**54754A-04**

# S E R V I C E N O T E

## 54754A Differential TDR Module

**TDR Module fails Vertical CAL, but passes after hot swap and re-test.**

Figure 1 – Semtech EZ1086, Wrong Part

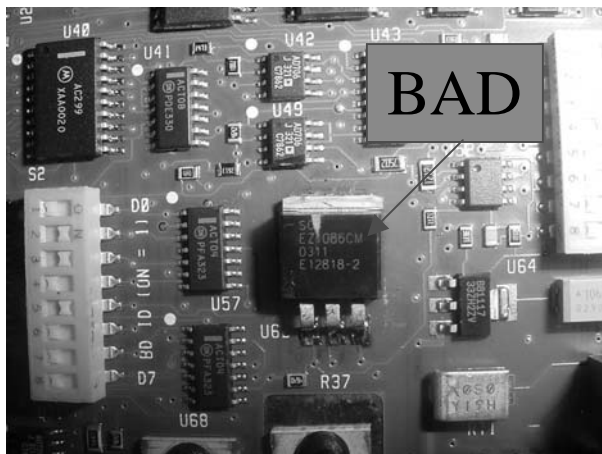
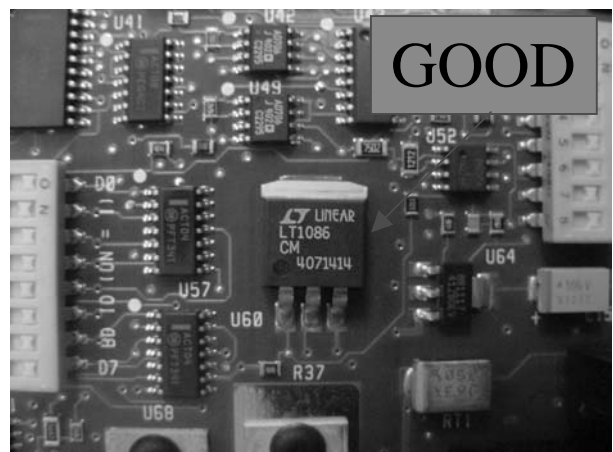
Some 54754-65501 Digital Boards were loaded with the wrong voltage regulator, Semtech EZ1086 (see Fig 1 below) and under certain power-up conditions, it may cause a module Vertical failure.

**Note:** Digital Board failures which do not have the wrong part loaded (Figure 1) or do not have this failure mechanism are NOT covered by this Service Note.

If a 54754A module fails module vertical cal in Case 1, but passes in Case 2 (Hot Swap), replace the digital assembly (54754-66501) per this Service Note.
